Consumers Power Company  
Palisades Plant  
Docket 50-255

Revision No 2  
Palisades Plant  
Suitability Training and Qualification Plan

June 11, 1984

Palisades Plant Suitability Training and Qualification Plan, Revision No 2,  
Outline.

FIGURE 1

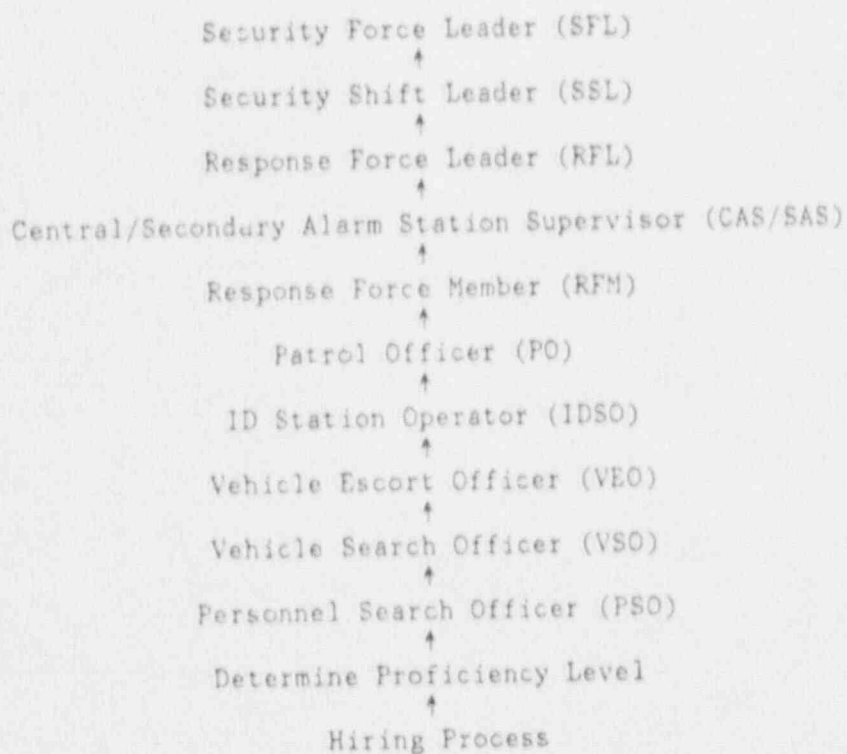
| Page | Section | Justification                                                                                                                                                                                                                                                                                                                                                                                                                                                                                                                                       |
|------|---------|-----------------------------------------------------------------------------------------------------------------------------------------------------------------------------------------------------------------------------------------------------------------------------------------------------------------------------------------------------------------------------------------------------------------------------------------------------------------------------------------------------------------------------------------------------|
| 2-1  | 2.1.2   | <p>This section was revised due to logistical problems, such as weather, facility and equipment availability and failure of security personnel to perform satisfactorily on the first attempt. These factors make it difficult to train and certify in a specific order.</p> <p>Our intent, however, remains as originally developed; that is, to have personnel trained and certified in their respective shift assignment and all shift assignments below it, requiring a lesser degree of knowledge and skill as described in Section 2.2.4.</p> |

- 2.1.2 The training/evaluation program begins as a portion of the hiring process. During the initial interview, it is determined if the individual has had any previous training and/or experience with similar security programs. If experience is indicated, the person will be evaluated to determine his or her specific training needs. The Company training program is designed to qualify personnel in their respective shift assignments as well as all shift assignments below it which require a lesser degree of knowledge and skill, as identified in Figure 1.
